**TRANSMITTAL OF TRANSMITTAL OF OHIO ENVIRONMENTAL PROTECTION  
AGENCY COMMENTS ON THE INTEGRATED ENVIRONMENTAL MONITORING  
PLAN (IEMP) MID-YEAR DATA SUMMARY FOR 2005**

**OHIO ENVIRONMENTAL PROTECTION AGENCY**  
**COMMENTS ON THE**  
**INTEGRATED ENVIRONMENTAL MONITORING PLAN**  
**MID-YEAR DATA SUMMARY FOR 2005**

**FERNALD CLOSURE PROJECT**  
**FERNALD, OHIO**

**MARCH 2006**

FIGURE A.2-31. TOTAL URANIUM CONCENTRATION VS. TIME PLOT FOR MONITORING WELL 2389

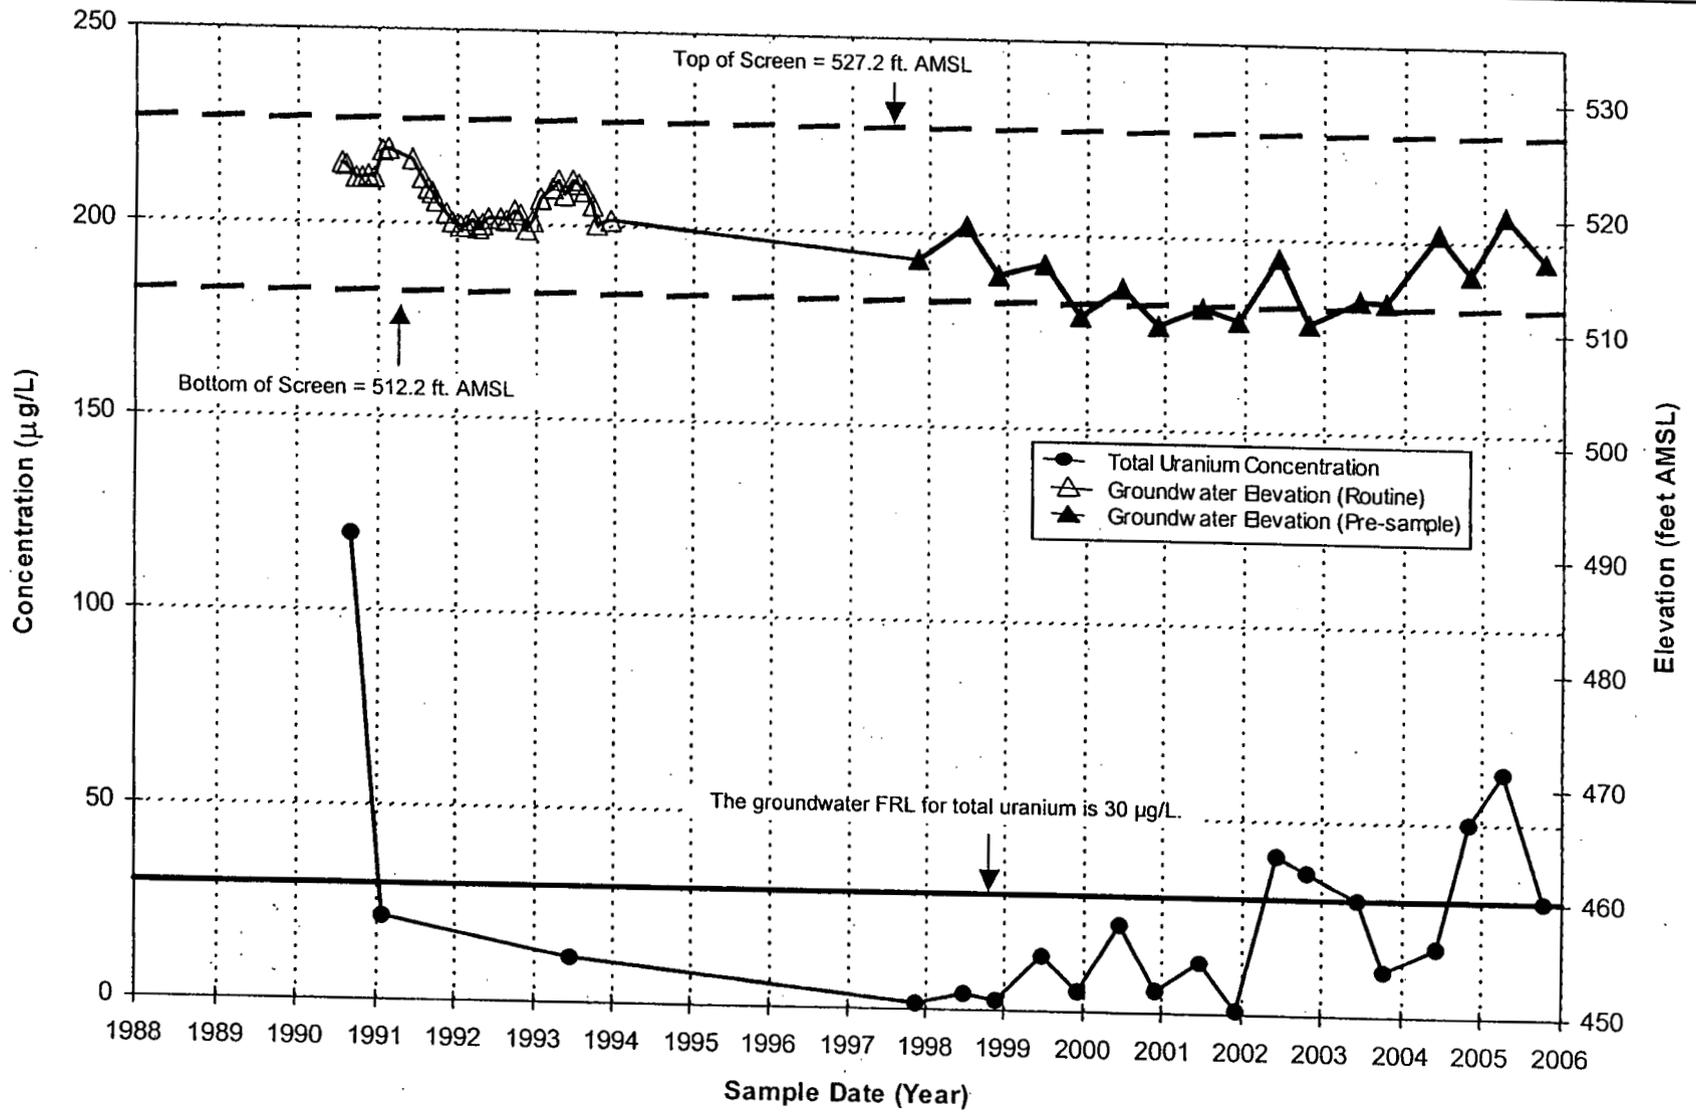
the module in order to maintain capture of the eastern edge of the South Plume. More recent groundwater modeling presented as Modeling Approach C in the Groundwater Remedy Evaluation and Field Verification Plan and Modeling Approach C in the Waste Storage Area Phase II Design Report has a modeled target-pumping rate of 200 gpm for RW-4. The ability to achieve a model predicted cleanup using a lower target pumping rate for RW-4 is attributed to stopping re-injection along Willey Road which allows more capture from the South Field Wells, and recent lower uranium concentrations in the area of the eastern most off-property lobe. The lower target-pumping rate of 200 gpm is scheduled to become effective at RW-4 on April 1, 2006, as noted in Revision 3 of the Operations and Maintenance Master Plan for Aquifer Restoration and Wastewater Treatment.

As stated in response.
